Council Reference: A007017328  
Attention: Alexandria Wood

**RE: Response to Information Request – Development Permit for Material Change of Use (Six Townhouses) at 44 Kates Street, Morningside**

We write on behalf of our client, EKOS Property Development, in response to Council's 1 June 2026 Information Request regarding development at 44 Kates Street, Morningside.

Figure 1: Proposed Site Plan with Increased Setback to Front Walls – Zarchitects (8 June 2026)

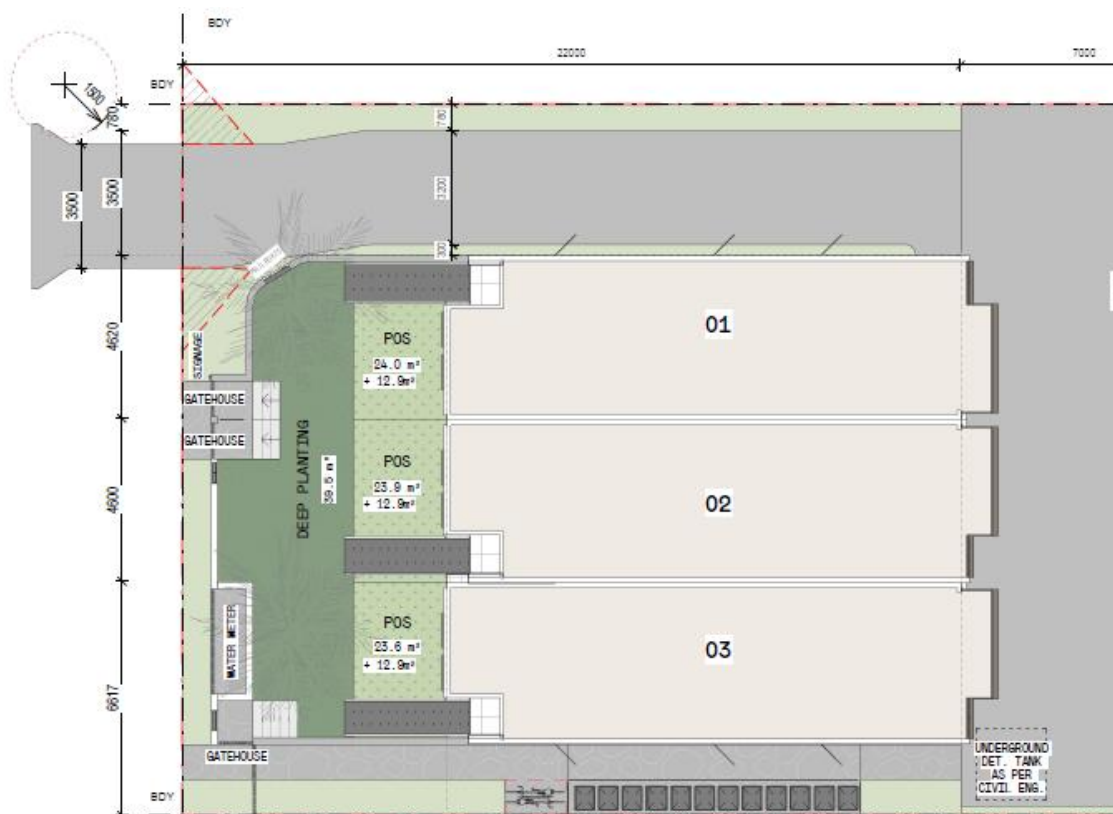
1. The proposed plans note that gatehouses, water meters and walls dominate the frontage which limits space for shade tree planting and detracts from the streetscape amenity. A minimum 2m wide landscape strip should be provided along at least 50% of the frontage with refuse bin enclosures and walls located behind this landscaping in accordance with PO28/AO28.1 of the Multiple dwelling code.

- a. Provide amended plans that show a minimum 2m wide landscape strip along at least 50% of the frontage with bin enclosures and walls located behind this landscaping.

Note: The refuse bin storage areas for Townhouses 1, 2 and 3 must be accessible internally without the need to enter the road reserve and cannot be accessed through deep planting areas, dwellings or garages. The access doors to the refuse bin storage areas for Townhouses 1, 2 and 3 must not open onto the road reserve. An internal access pathway to the refuse bin storage areas will need to be provided on the revised plans.

2. The eastern side of the subject site does not provide sufficient landscaping in accordance with PO28/AO28.2 of the Multiple dwelling code. The landscaped area along the eastern side boundary should be redesigned to accommodate screening vegetation, contributing to building separation and privacy. The pedestrian pathway should be aligned adjacent to the building line. Waste bins may be located at the boundary, within a designated gap in the landscaped strip.
  - a. Provide amended plans demonstrating a minimum 1.5m wide landscaped strip along the eastern side boundary. The pedestrian pathway is to be relocated along the building line, incorporating a gap for bin storage.

As detailed on both the accompanying proposal plans and landscape plan, the previously proposed bin stores have been removed from the front of the site. The proposed gatehouse and front walls have been retained with a setback 1000mm from the road boundary. The removal of the bin stores has allowed for the 1000mm setback to be clear of built form across the entire width of the frontage. As detailed on the proposed landscape plan this front setback is to be landscaped with shrubs and ground covers to assist with visual amenity within the streetscape. The removal of the bin stores has allowed for additional deep planting within the front setback between the structures and the road boundary assisting in softening the development from the street.

As indicated within Figure 1 above, the pedestrian access path has been realigned to directly abut the eastern elevation of Townhouse #3. All bins including those previously proposed at the front of the site have been relocated to the bin store, which is now proposed in a screened enclosure along the eastern boundary, as advised by Council. Where possible columnar trees and screen planting have been provided in the 1000mm wide landscape strip along the boundary. As outlined within the Planting Schedule within

Figure 3: Proposed Bulk Earthworks Plan – Motus Consulting (18 June 2026)

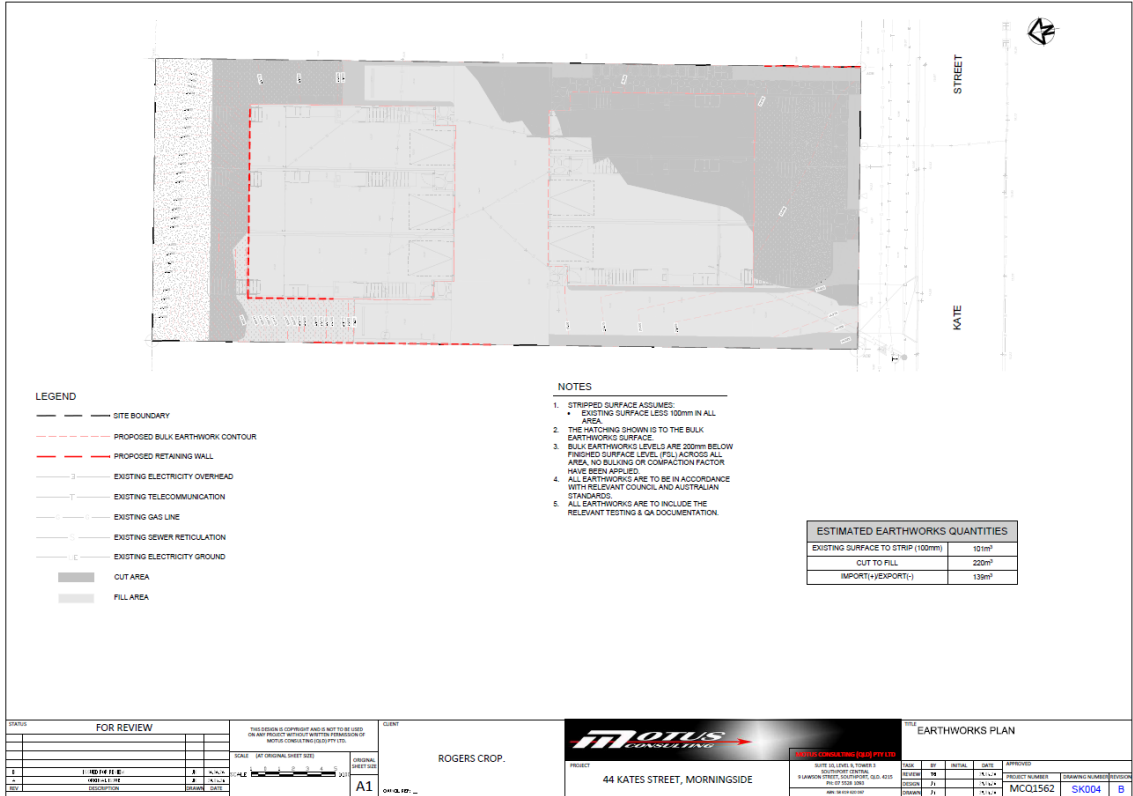
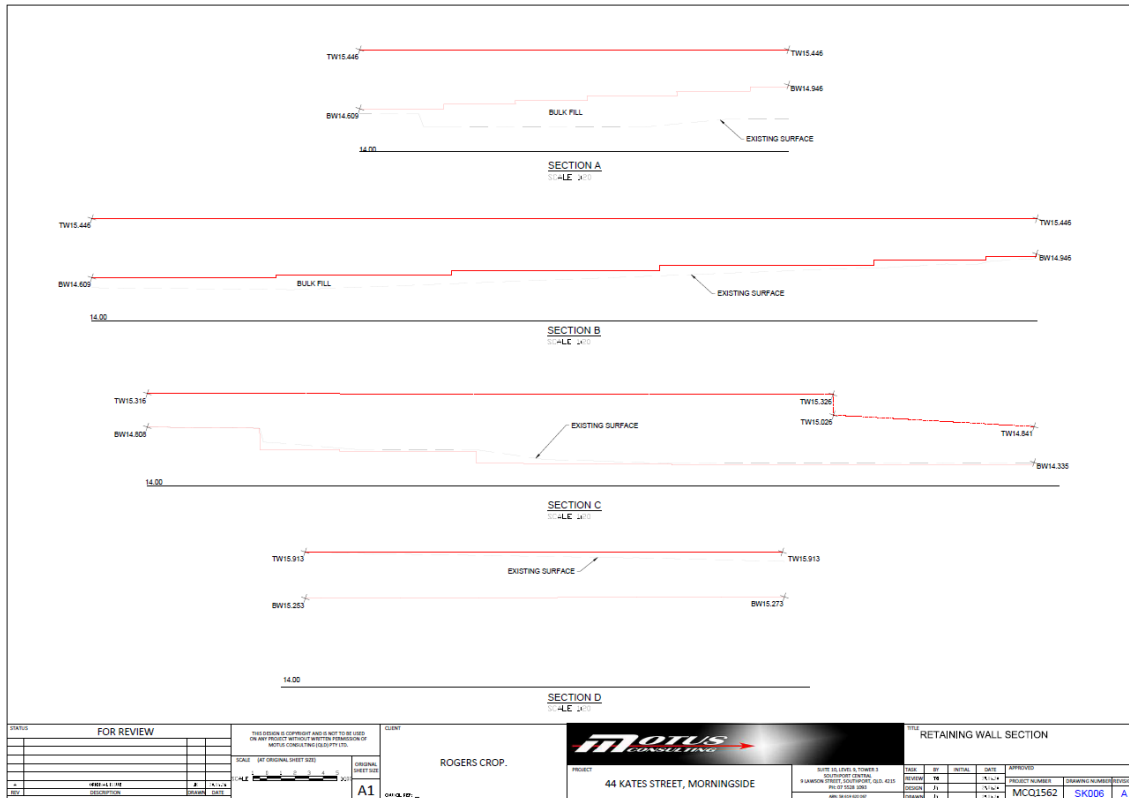
b. Provide a preliminary concept earthworks plan that includes cross sections showing the proposed extent of cut and fill.

Note: The maximum height of a retaining wall on a property boundary retaining fill and presenting outwards is to be one metre. Any further retaining is to be stepped with a minimum one metre horizontal step between the tiers.

Accompanying this submission are plans prepared by Motus Consulting which detail the extent of cut and fill proposed and cross sections detailing the proposed works. All proposed works are consistent with the Filling and Excavation Code. As illustrated, there will be no large fill retaining walls presenting to the street or adjoining properties.
